SERVICE BULLETIN

APPLICABILITY: 2019 MY Outback & Legacy / Key Start Ignition **NUMBER:** 15-299-22R
SUBJECT: Remote Engine Starter (RES) / **DATE:** 08/02/22
Intermittent Horn Beeping Discontinued **REVISED:** 06/05/23
Part Number H001SAL003

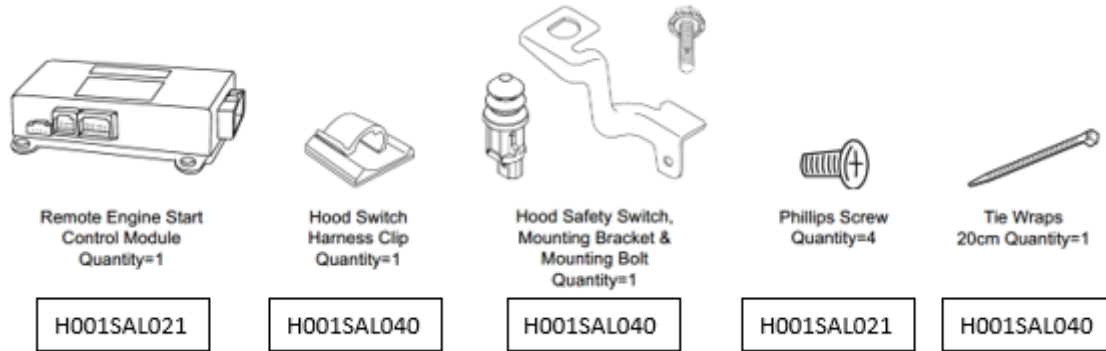
BOTH part numbers H001SAL021 (RES Control Module) and H001SAL040 (Hood Switch & Bracket) are required. The components included are shown below.

Part Description	Part Number
REMOTE ENGINE START ECU	H001SAL021
HOOD SWITCH / BRACKET	H001SAL040
